# 1954 Corvette: Service Bulletin: Connecting Rods

**Subject:** Connecting Rods

**Bulletin No:** DR-164

**Date:** January 13, 1954

**REWORKING 1953 POWERGLIDE ROD FOR  
USE IN 1954 POWERGLIDE ENGINE**

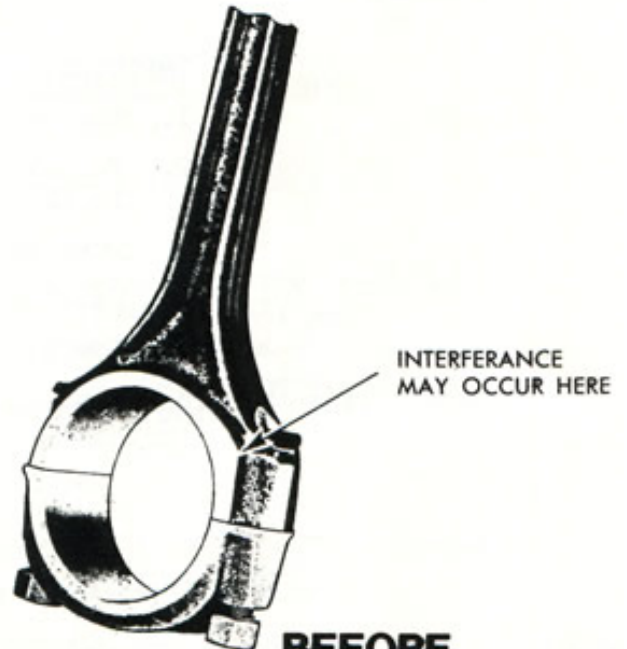
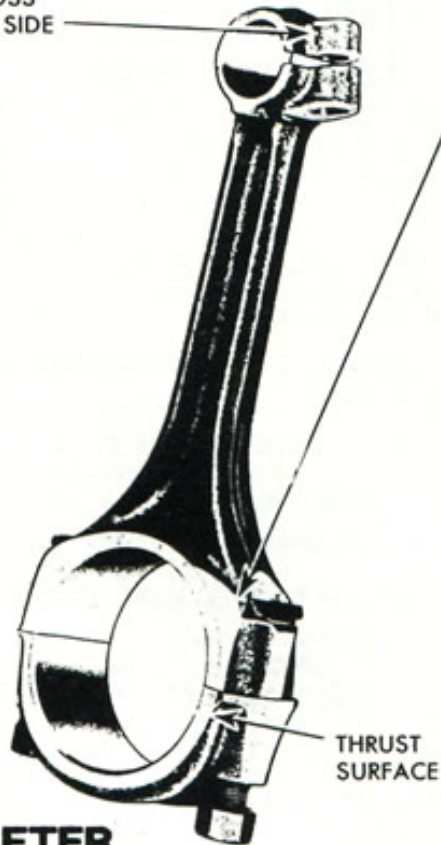
if the 1953 Rod is not reworked, interference may occur between the new wide lobed (9/16") camshaft and the number 2, 4 and 6 rods on the camshaft side at the rear of the rod in the area at top of connecting rod bolt.

RELIEVE THIS AREA  
BY GRINDING AS SHOWN.  
GROUND AREA SHOULD BE  
AT 30° WITH THRUST SURFACE  
OF ROD-CAMSHAFT SIDE-REAR  
ON NO. 2, NO. 4, NO. 6 RODS

Until such time as the 1954 Passenger Car Powerglide Connecting Rods are available and it is necessary to replace a rod in a 1954 Powerglide Engine, the 1953 Powderglide Rod may be used after reworking.
